# Product Change Notification

**Change Notification #:** 119367-00

**Change Title:** Intel® Server System R2208WFTZSR, PCN 119367-00, Product Design, Label, Power Supply and Label Update

## Power Supply Label

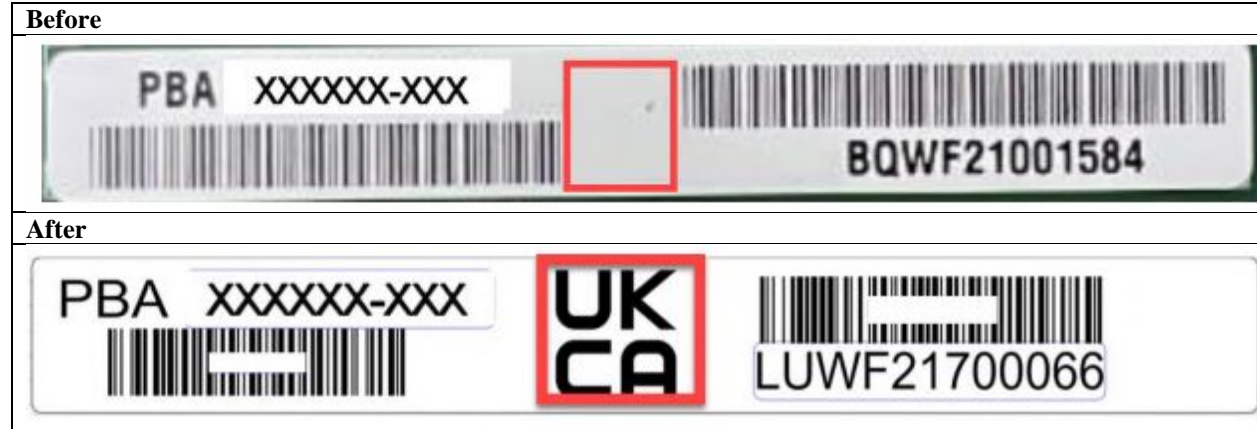
- Adding the UKCA logo in the Server Board Serial Number Label
- The 1300W Power supply is changing from H79286-011 to H79286-012 due to a firmware upgrade from 26.5.128 to 29.5.128 and a minor hardware change, there is no impact on functionality
